CURB RAMP AND SIDEWALK NOTES

MAIN STREET RESURFACING

Federal-Aid Project No. NH-032-1(010)

Date: September, 2014

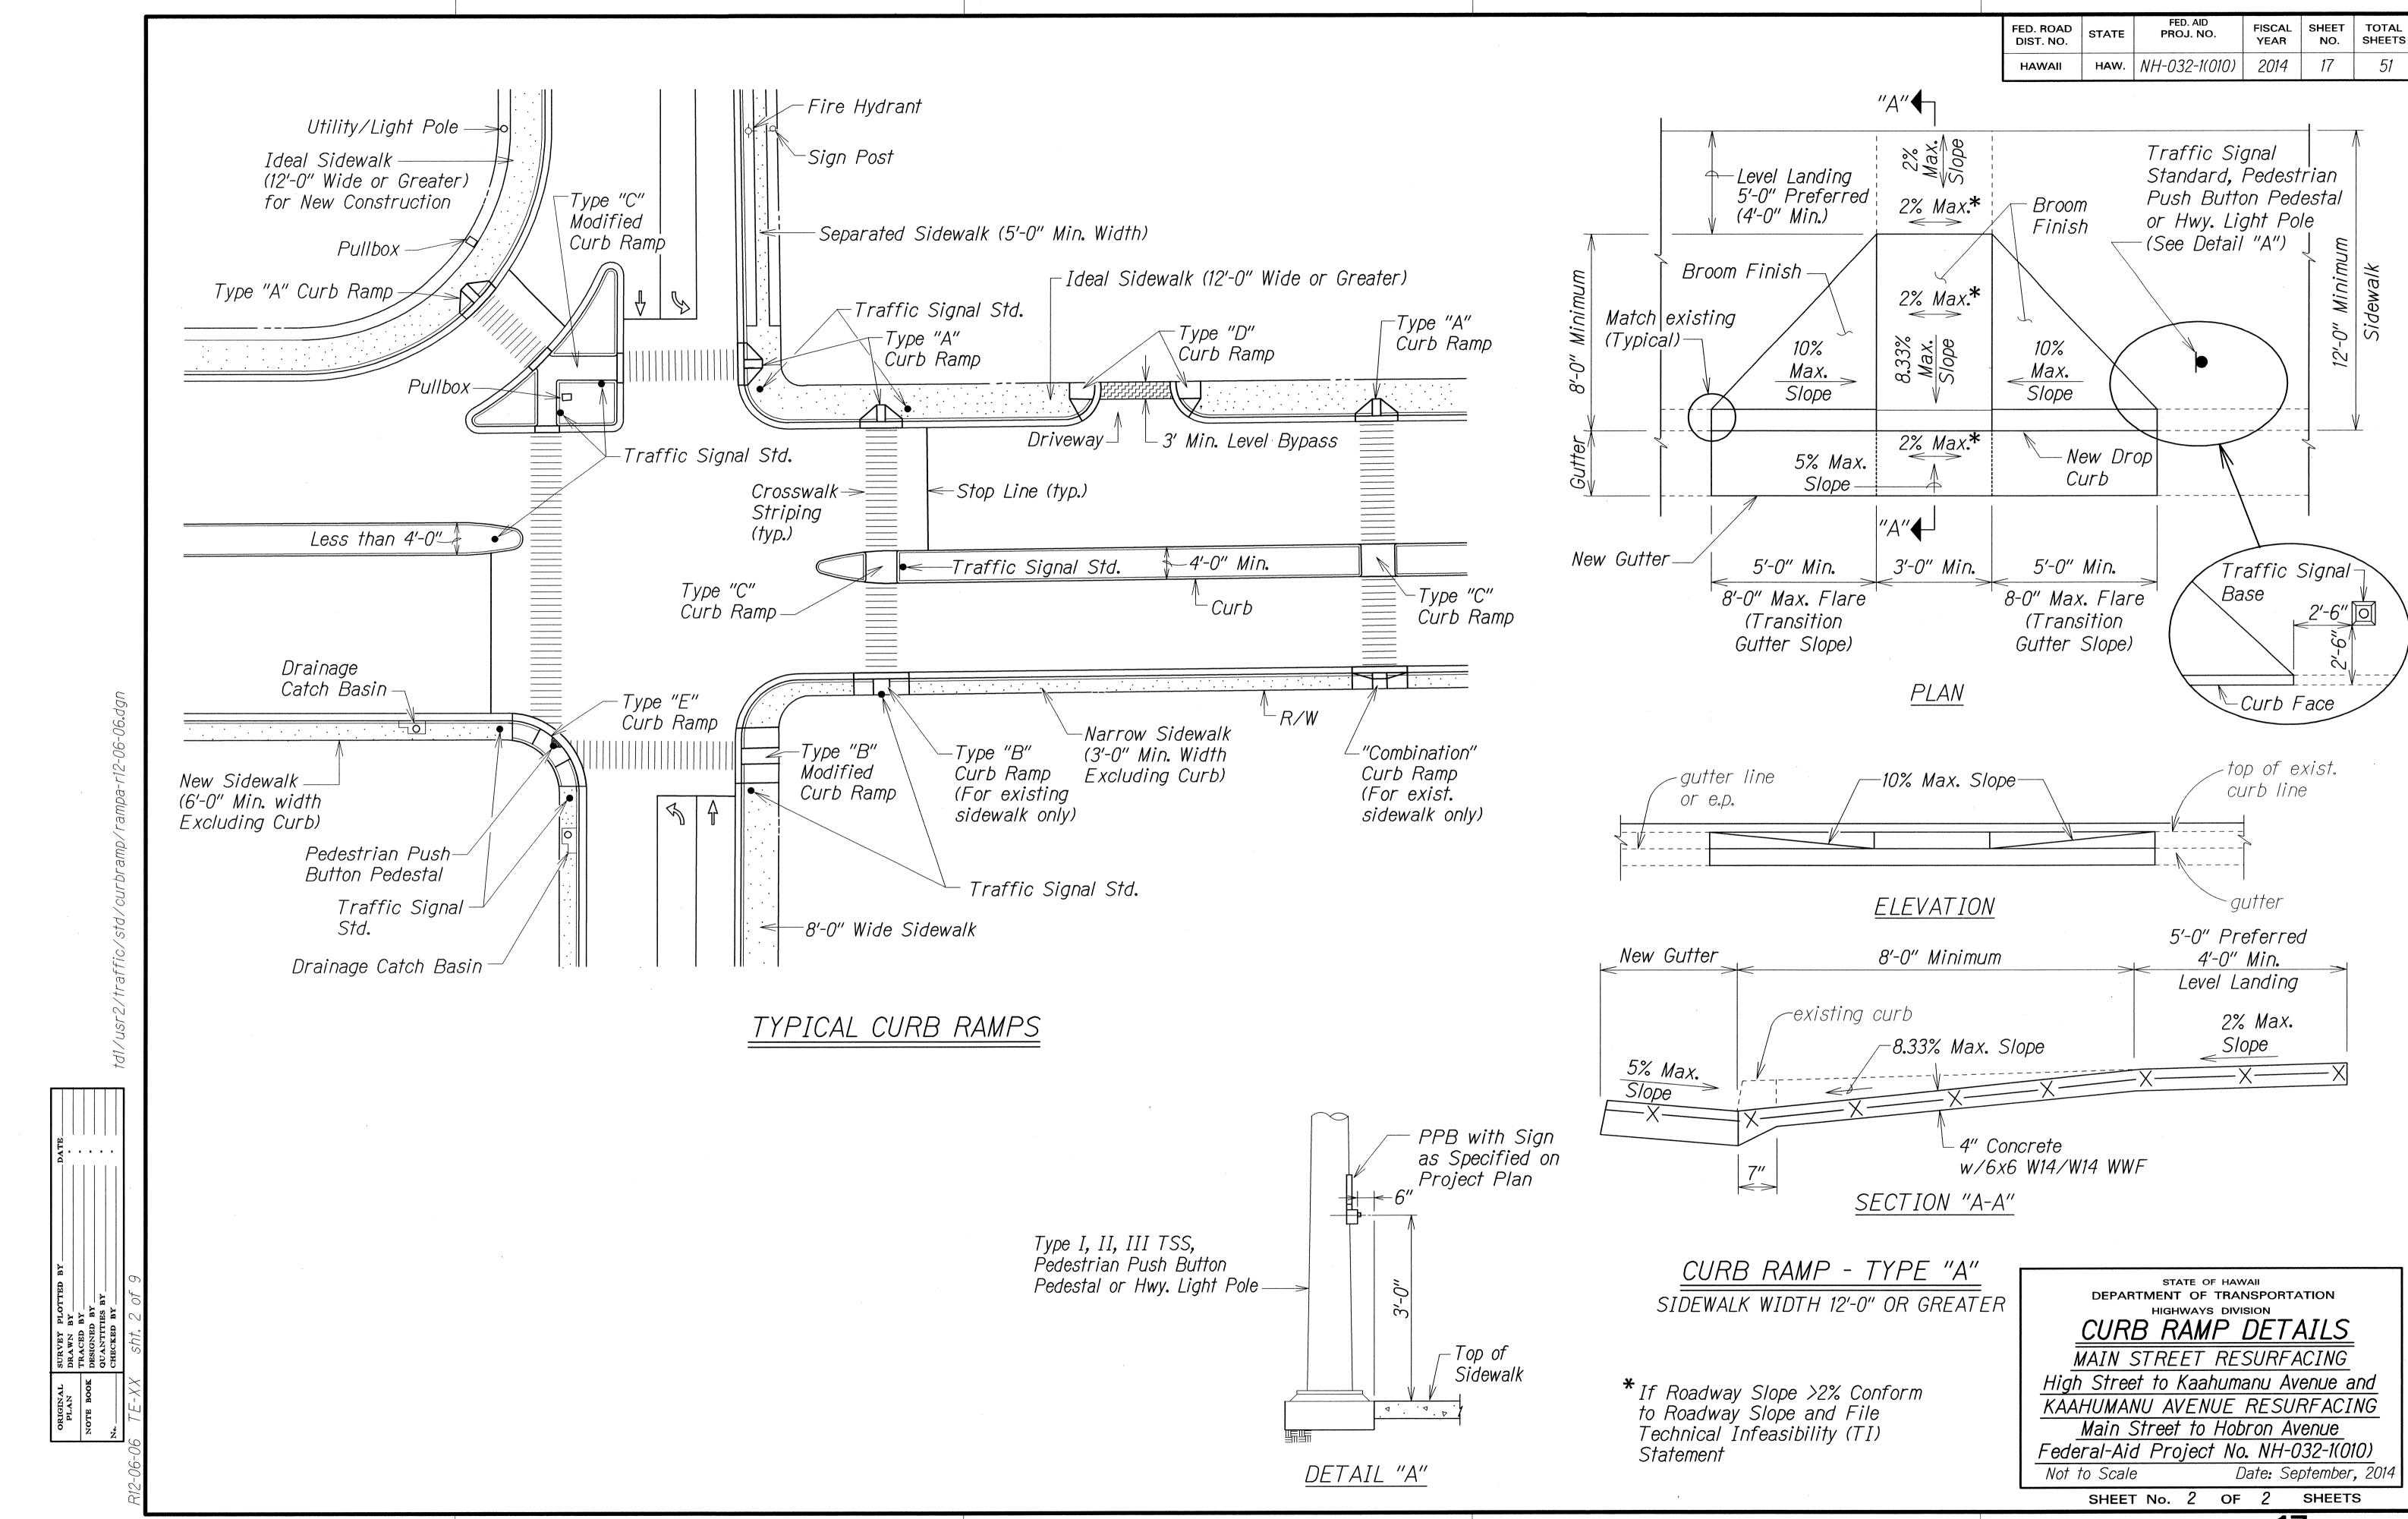
12/8/14 Removed detectable warning detail and notes
